## TECHNISCHE MITTEILUNG / TECHNICAL BULLETIN

Nr. 914-03 July 1997

Calibration of the mixture enrichment jet of ROTAX 914 F (series)

Engines of **type 914 F (series)** from S/N 4,420.002 to S/N 4,420.029 and from S/N 4,420.032 to S/N 4,420.044.

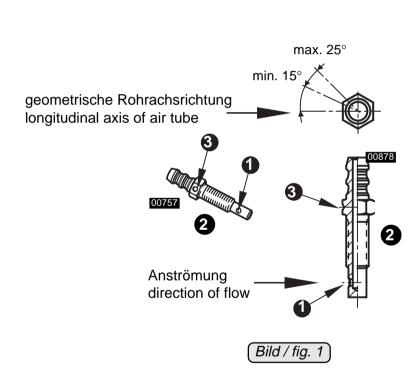
The pressure control bore 1 in the mixture enrichment jet 2 has to be positioned min. 15° to max. 25° deviating to the theoretical flow direction.

This becomes necessary as the turbo charger causes a twist of the air flow which would result in an unfavourable angle of attack on the pressure control bore, if installed straight.

The position of the pressure control bore is indicated clearly by the counter sinking 3 on the hexagon. See fig. 1 and 2.

With the longitudinal axis of the intake tube as reference, mark the tube at an angle of  $15^{\circ}$  to  $25^{\circ}$  in clockwise direction.

Afterwards slacken the locknut and readjust enrichment jet by aligning counter sinking 3 on hexagon with mark on intake tube. Tighten lock nut and secure with paint.
